# LaserControl Problem statement

# Proposed solution

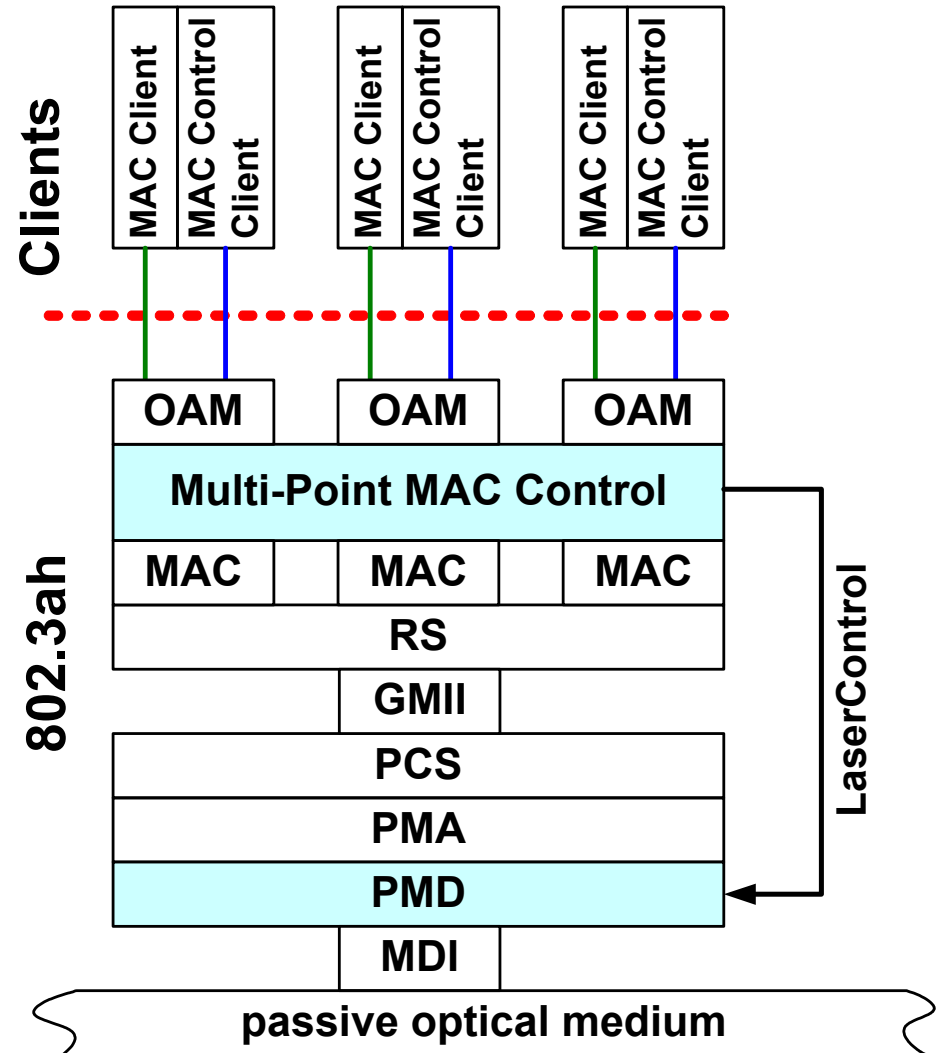
- Current ONU layering model requires **LaserControl** signal to go from MAC Control sublayer to PMD sublayer
- This signal jumps over **MAC, RS, GMII, PCS, and PMA** sub-layers
- **It is a layering violation**

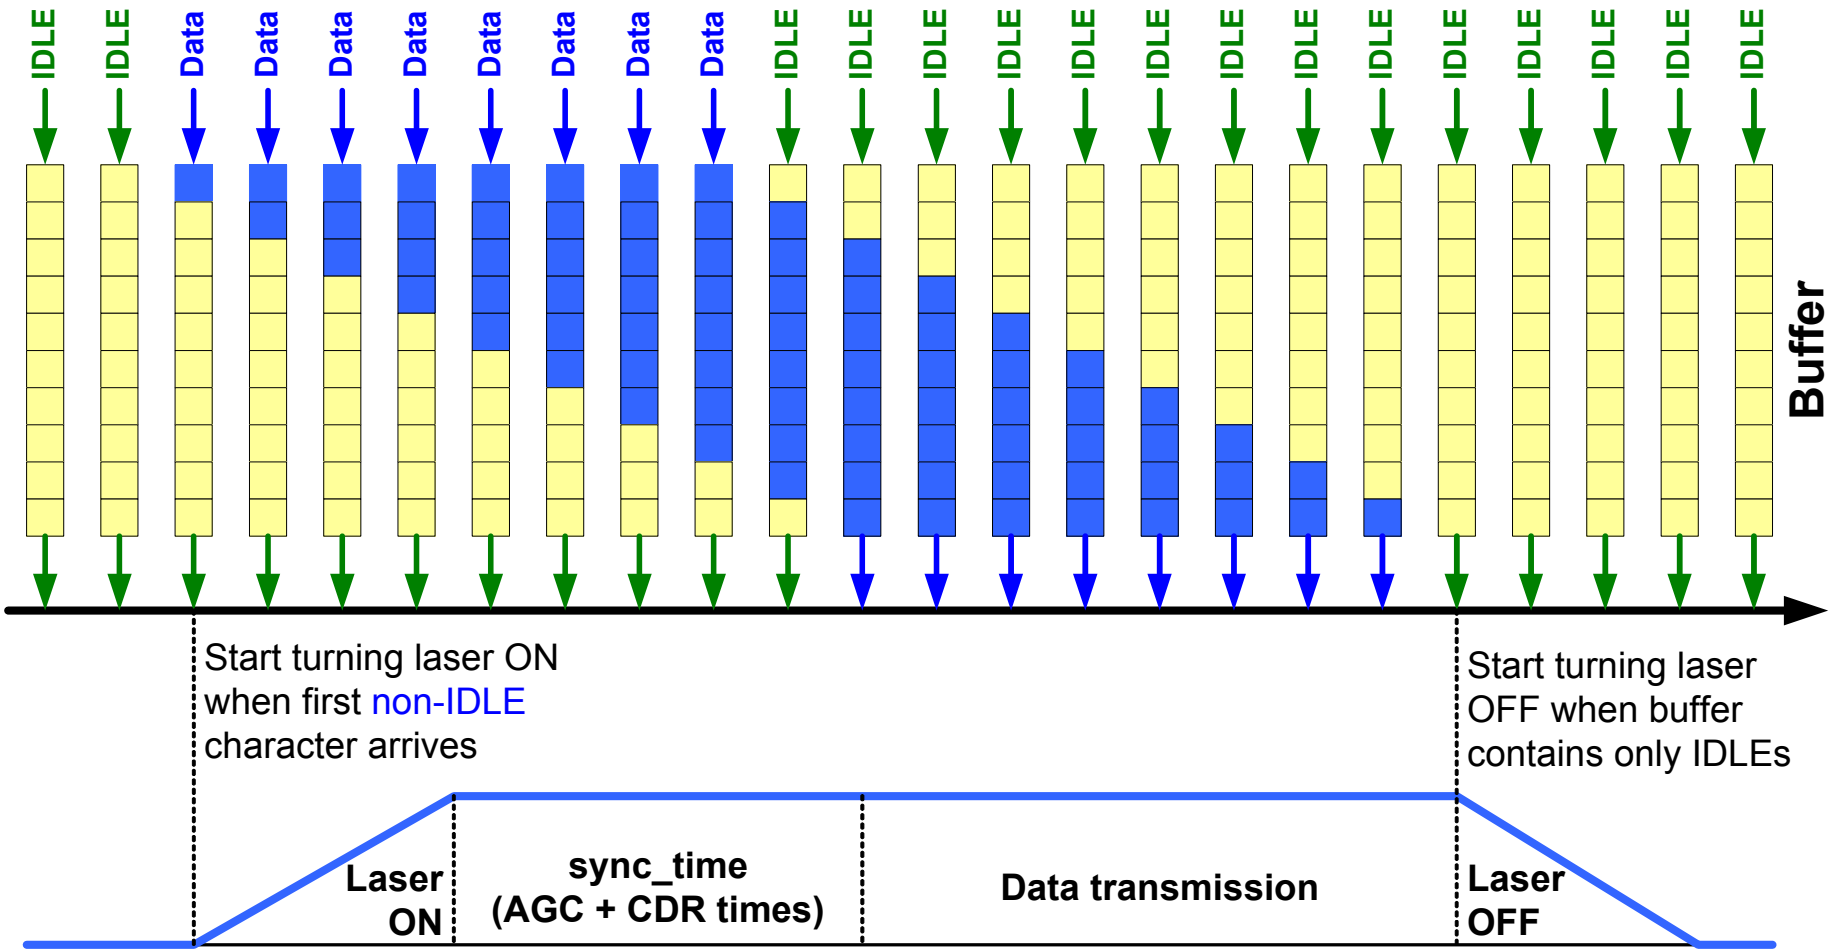
- PHY can be modified to autonomously determine times to turn laser on and to turn laser off
- LaserControl line between MAC Control and PMD is not necessary

# Illustration of the approach

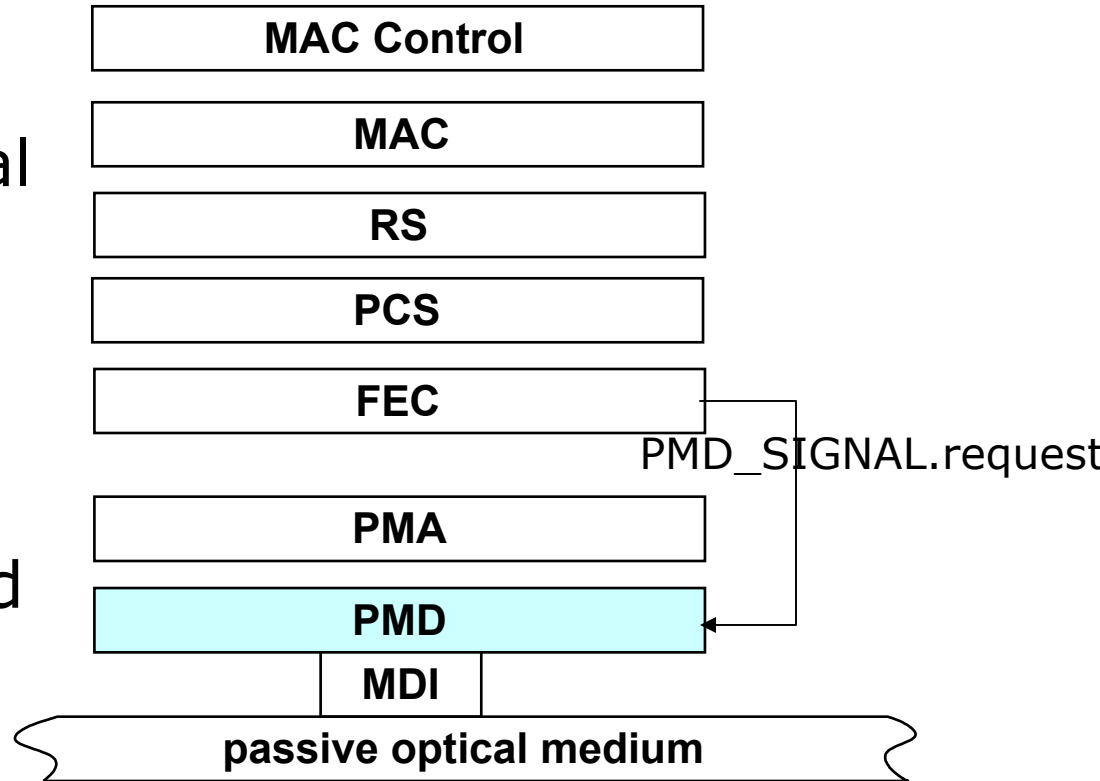
- Layering model satisfied
- LaserControl signal to go from FEC sublayer to PMD sublayer
- This signal propagates around PMA (like SD)
- Layering satisfied

# Implementing IPG Stretch Function

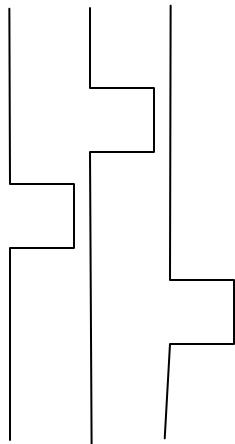
- Clause 4 changes required for IFSSStretch mechanism for rate adaptation used in FEC
- Transmission from MACs may violate minimal IPG requirement when switching transmitters

# Location

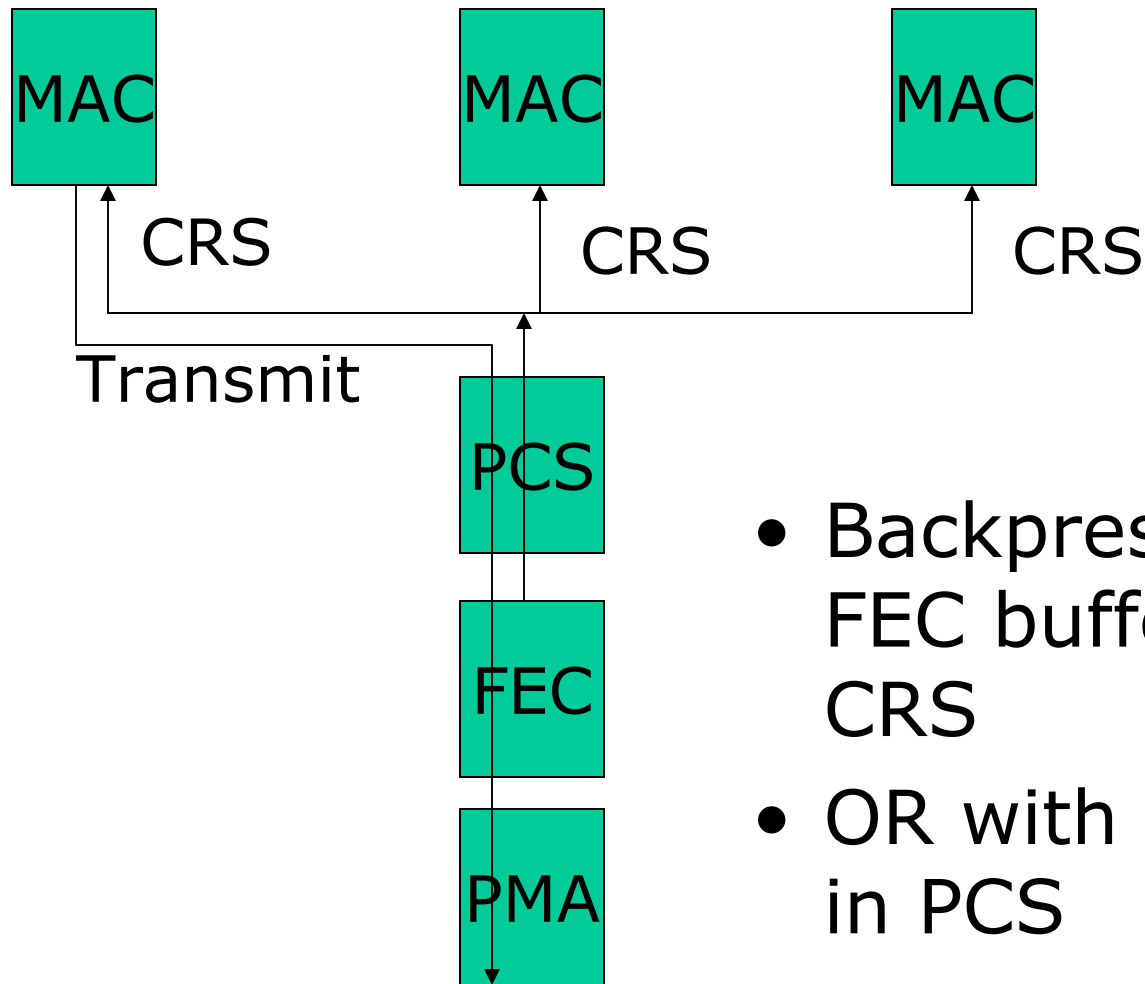
- Backpressure from FEC buffer activates CRS
- OR with existing CRS in PCS
